Project	IEEE 802.16 Broadband Wireless Access Working Group http://ieee802.org/16 >		
Title	Clarification of OFDMA Private Maps		
Date Submitted	2004-11-18		
Source(s)	Yuval Lomnitz, Hassan Yaghoobi	Intel Corp	yuval.lomnitz@intel.com, hassan.yaghoobi@intel.com
	Tal Kaitz, Ran Yaniv	Alvarion	tal.kaitz@alvarion.com, ran.yaniv@alvarion.com
	Dave Pechner, Doug Dahlby, Todd Chauvin	ArrayComm Inc.	dpechner@arraycomm.com, dahlby@arraycomm.com, chauvin@arraycomm.com
Re:	IEEE P802.16-REVd/D5		
Abstract	This contribution introduces clarifications for OFDMA private maps		
Purpose	Adopt into P802.16d/D5 corrigenda		
Notice	This document has been prepared to assist IEEE 802.16. It is offered as a basis for discussion and is not binding on the contributing individual(s) or organization(s). The material in this document is subject to change in form and content after further study. The contributor(s) reserve(s) the right to add, amend or withdraw material contained herein.

Clarify OFDMA AAS private maps

Figure 219—Illustration of OFDMA frame with multiple zones

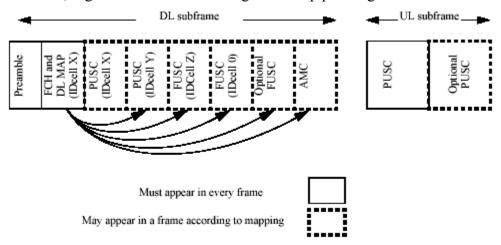
The current definition of DL maps (both regular and compressed) suggest that there is only a single DL map per frame, and that this DL map must occur immediately following the FCH. Therefore, by this interpretation, the current standard does not support private maps.

This eludes to the fact that the DL Map must be directly after the FCH and that there is only one DL MAP.

In addition, Figure 219 illustrates a single DL map pointing to all zones.

It is proposed to allow compressed maps to exist anywhere within an AAS Zone. When located in an AAS zone, the private map can be pointed to by a broadcast map, a DLFP message, or another private map in a previous frame. If the private map shares an allocation with other management messages or a data PDU, then the private map must be the first element in the allocation. Private maps are only allowed to use unicast CID values. Allocations pointed to by a private map must occur within the same AAS zone as the private map. Both UL and DL allocations are relative to the next frame.

The compressed map must occur directly after the DL Frame Prefix, or can be used as a private map in an AAS zone. When located in an AAS zone, the private map can be pointed to by a broadcast map, a DLFP message, or another private map in a previous frame. Other restrictions of private maps include:

- The private map must be the first message in a PHY burst
- Private maps are only allowed to use unicast CID values.
- Allocations pointed to by a private map must occur within the same AAS zone as the private map.
- Both UL and DL allocations included in the private map are relative to the next frame + frame offset value negotiated with the SS (see 11.8.3.7.6).
